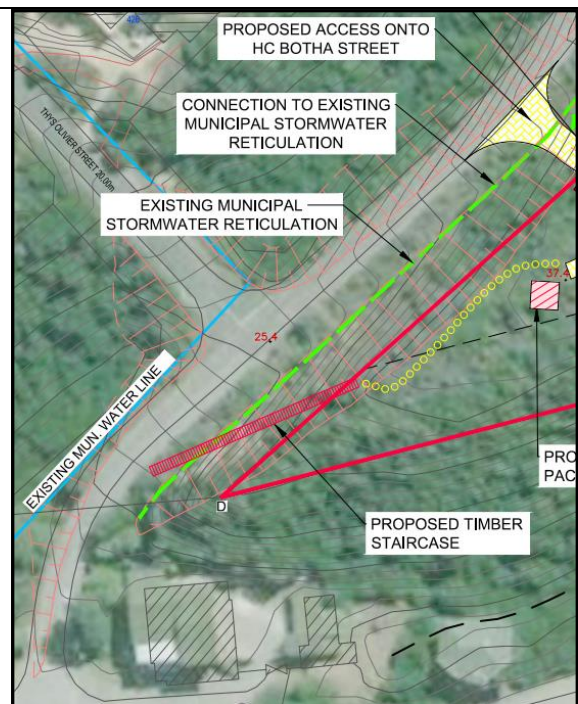
<p>Kommentare en bekommernisse gelees deur oa mnr Hannes v WYK insake die verlenging van die geplaveide sypaadjie in die rigting van Morrisonweg.</p> <p>Jul spesialiste se regtig deursigtige verskoning om nie die sypaadjie te plavei nie omdat 'n melkhoutboom sogenaamd</p>	<p>Aanvanklik was voetganger toegang voorgestel in die vorm van 'n voetpaadjie en hout trappies deur Erf 720 tot in H.C. Botha Straat, met die eind punt baie naby aan die bestaande ingang van Dwarswegstrand oord (sien asb uittreksel van oorspronklike uitleg plan hieronder).</p>
